MAYOR AND COUNCIL OF THE TOWN OF WINDERMERE

January 24, 2023

Re: Third Town Council Workshop Windermere Downtown PUD Final Engineering Plan

WINDERMERE
DOWNTOWN
PROPERTY

LANDSCAPE PLAN

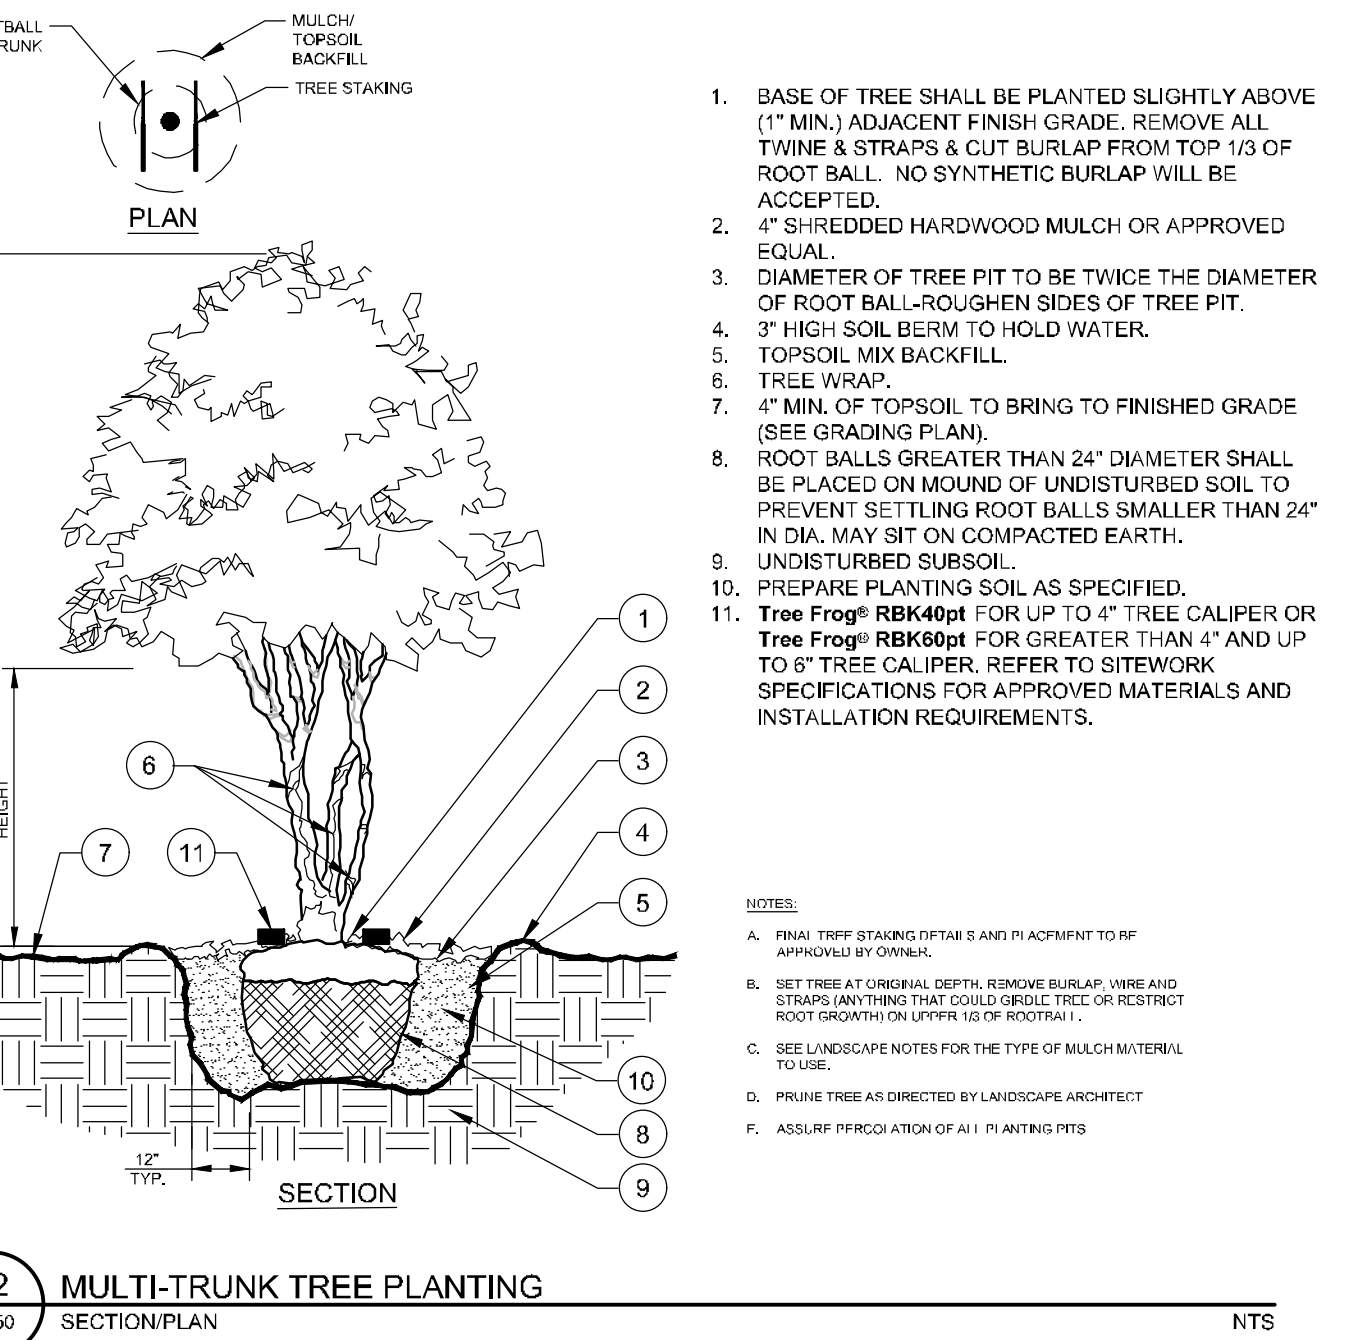
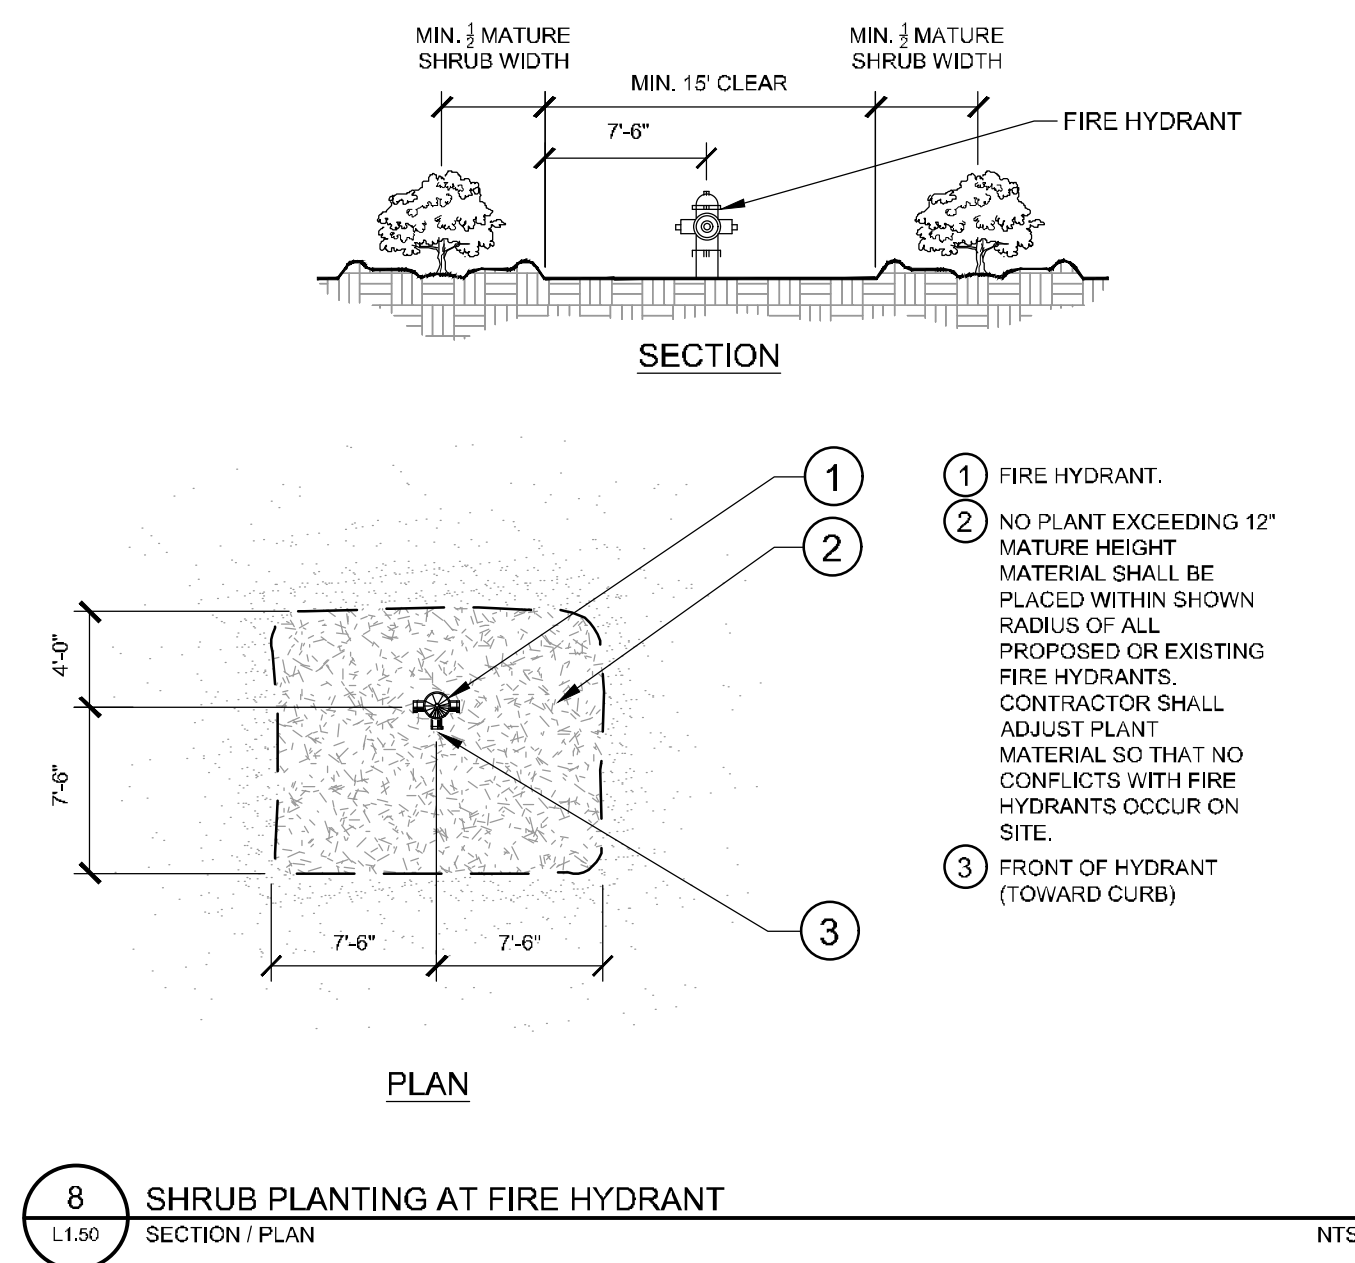
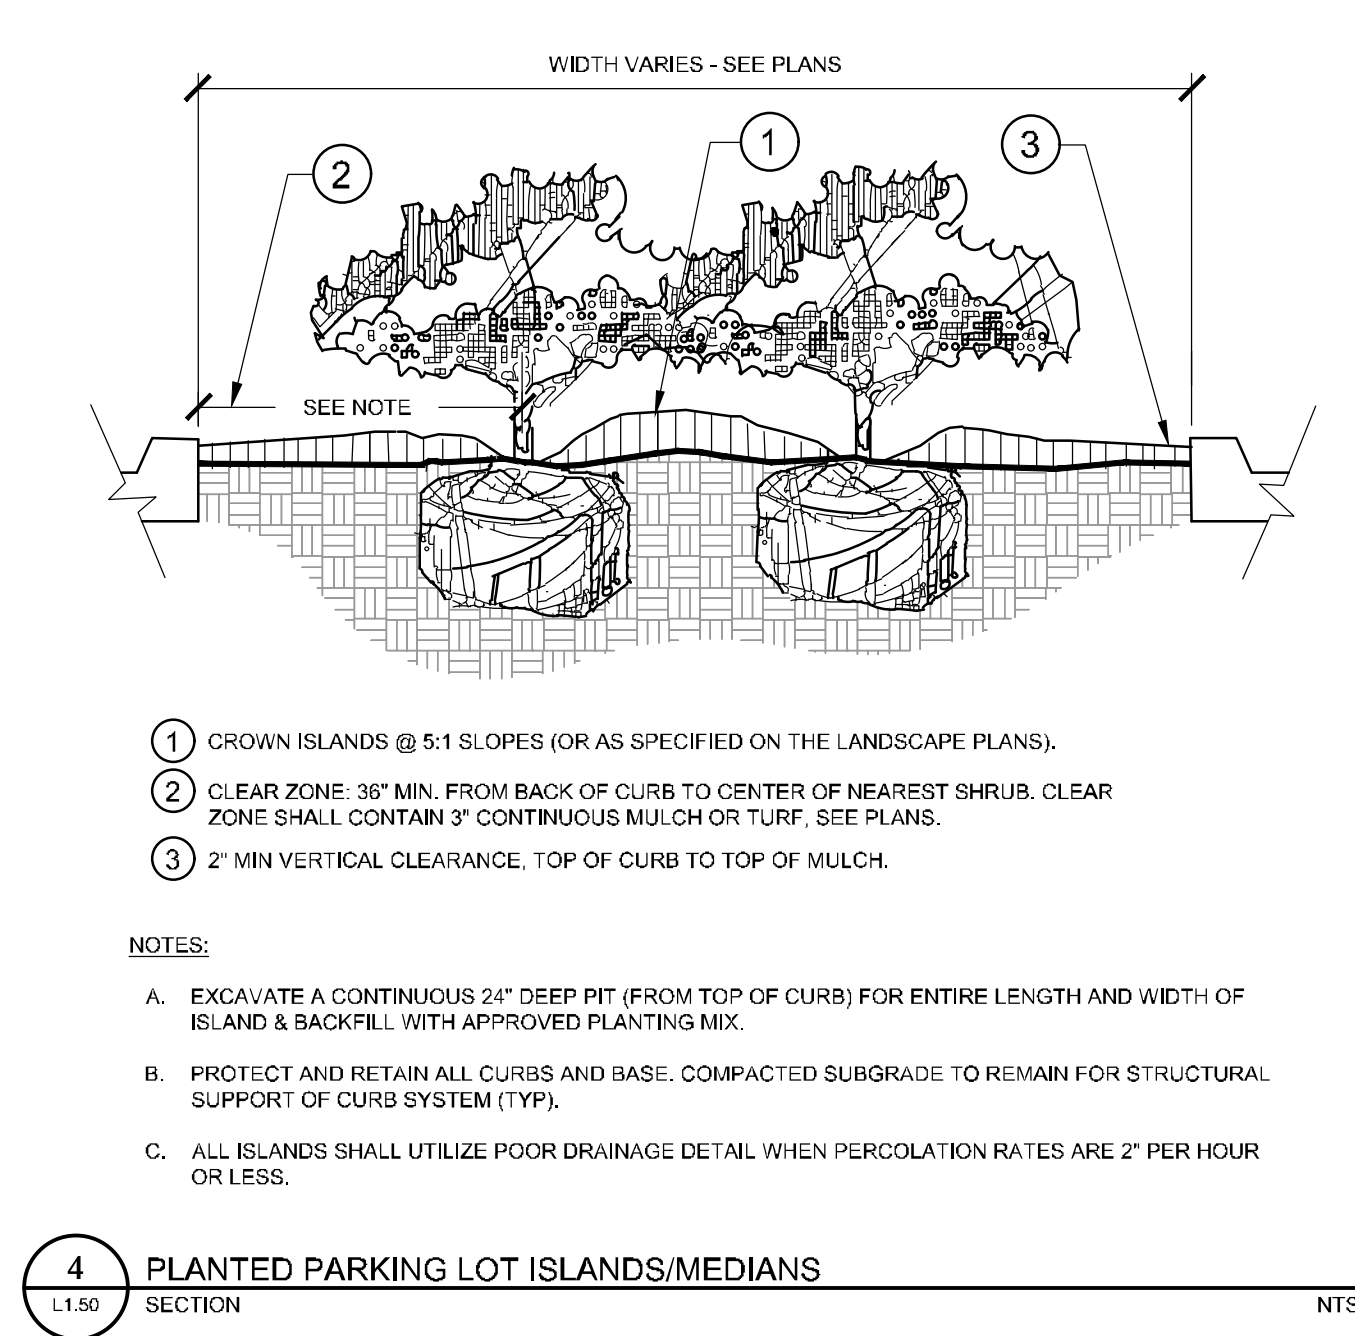
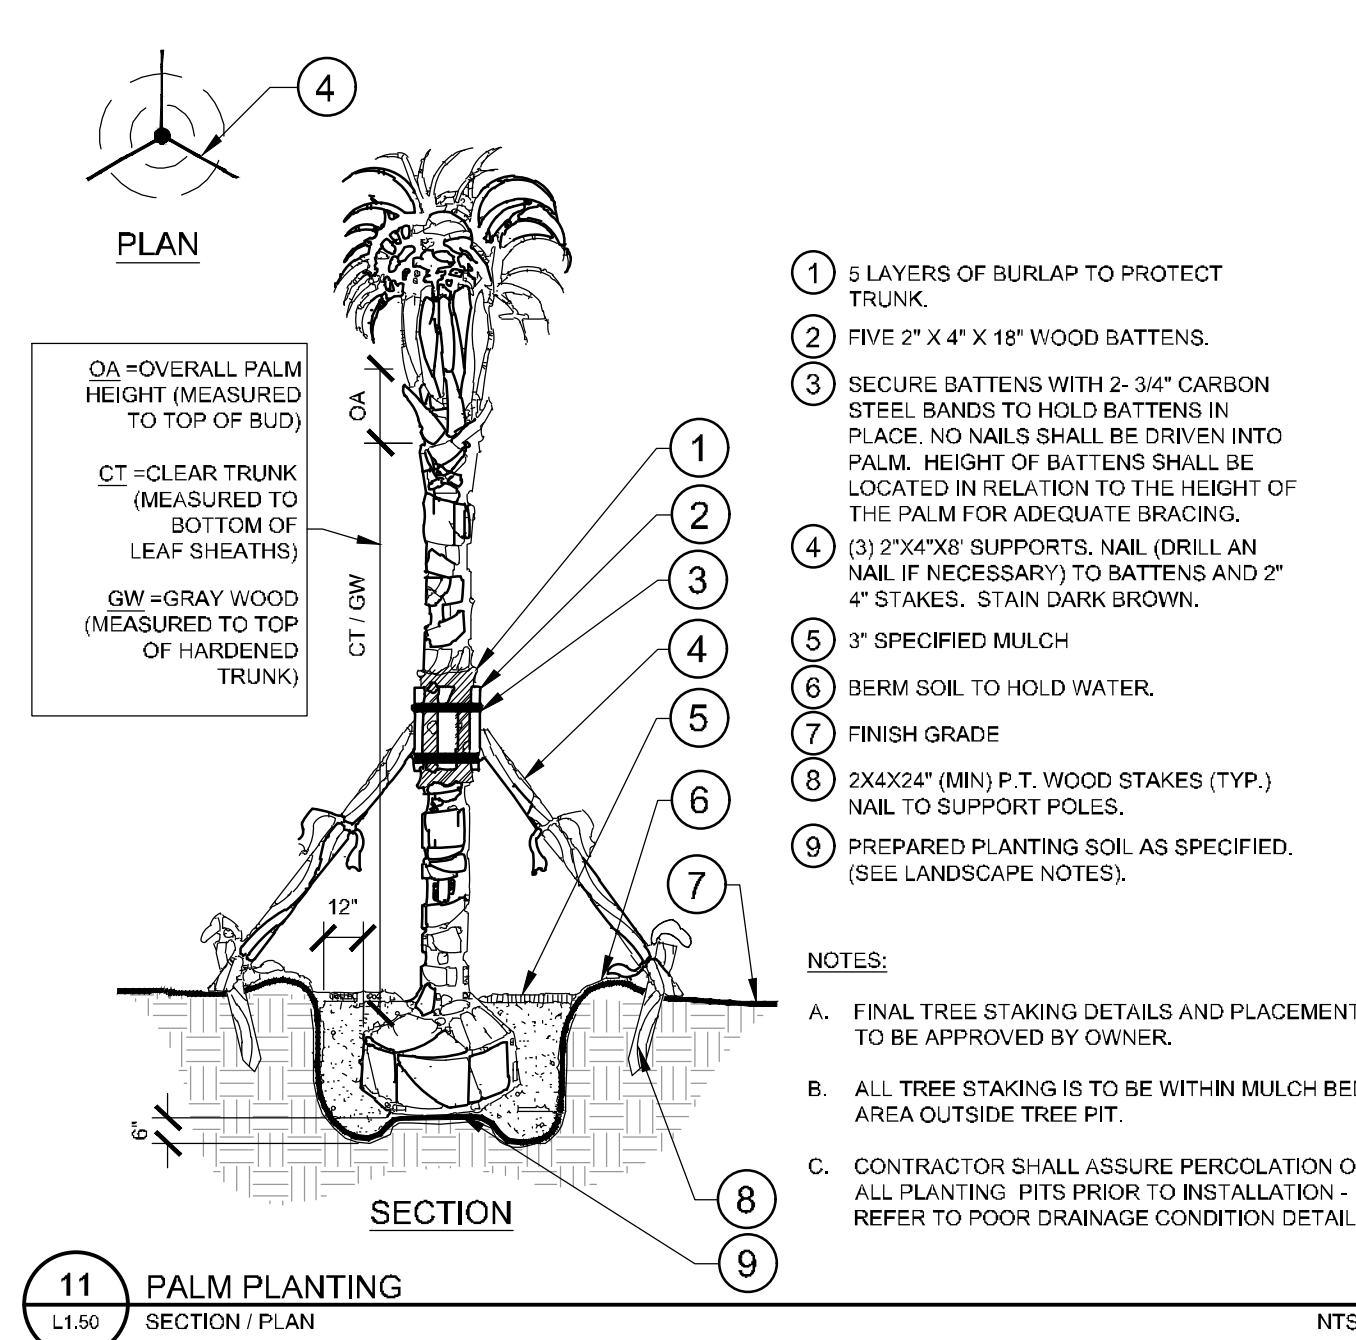
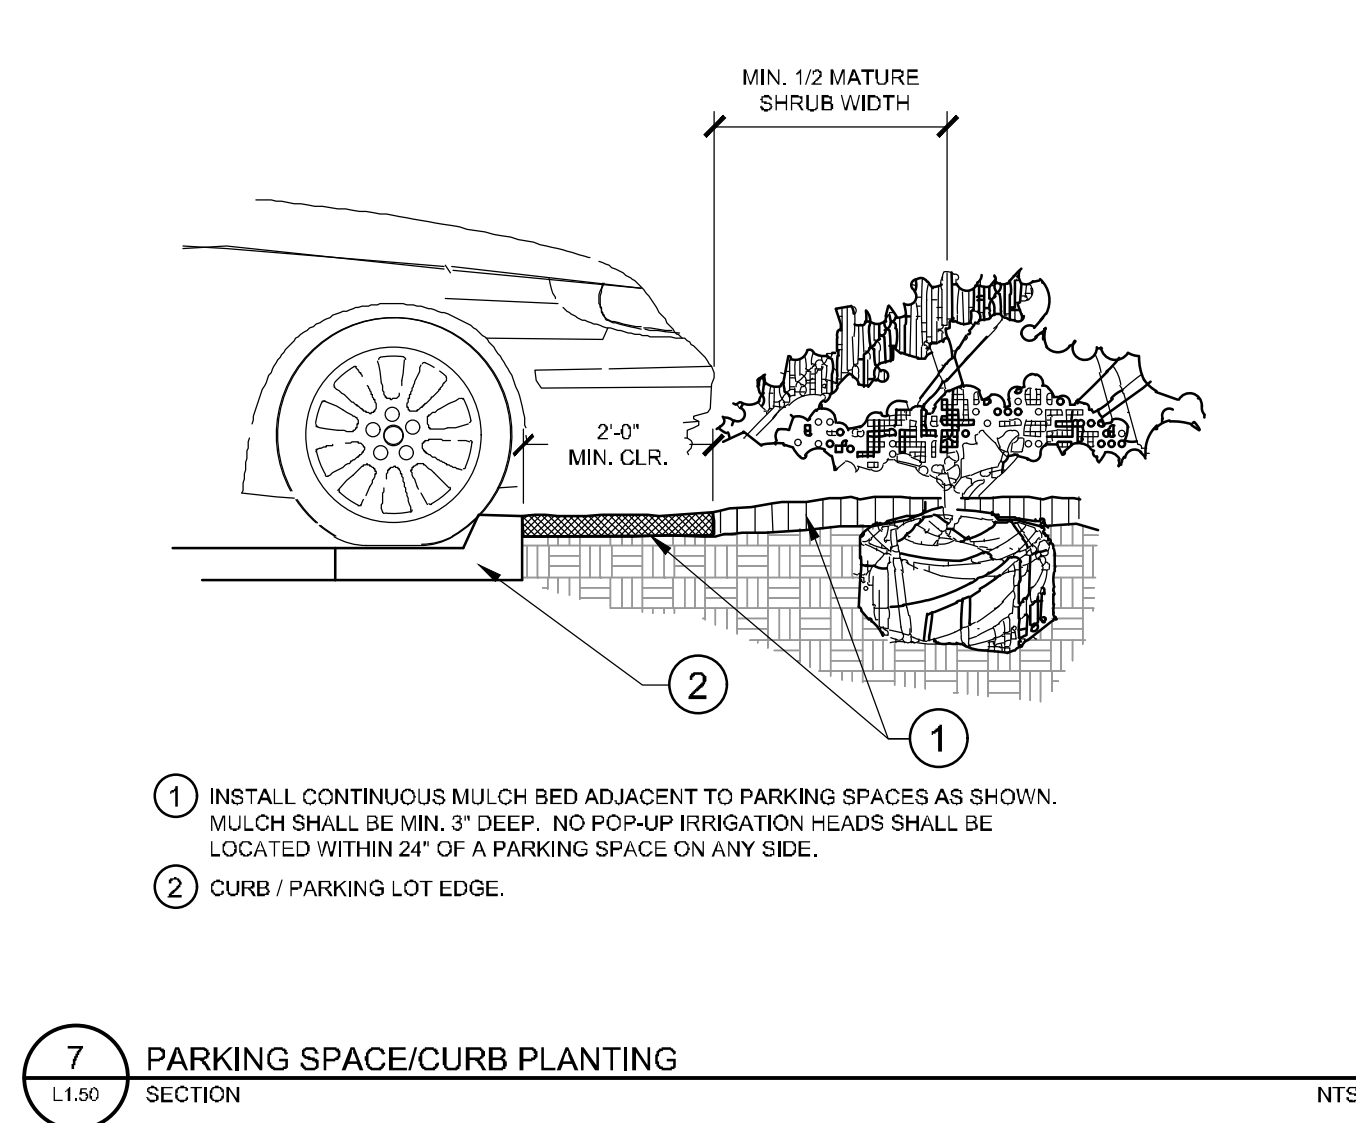
2. The proposed buffer wall between the parking lot and E 6th Avenue is shown as only 3 feet in height. The Town's Town Center Design District requires all buffer walls between the parking lot and ROW be 6 feet in height. I am aware there was discussion during the Tree Board reviews and site visit about reducing the height to 3 feet along E 6th Avenue. However, I have received comments from residents that live on Oakdale Street to the south of E 6th Avenue that the 3-foot wall will not appropriately shield headlights from the parking lot reaching their homes directly across E 6th Avenue. Because the Town Center Design District requires the 6-foot buffer wall height, I will have to make that comment during the next Town Council workshop.
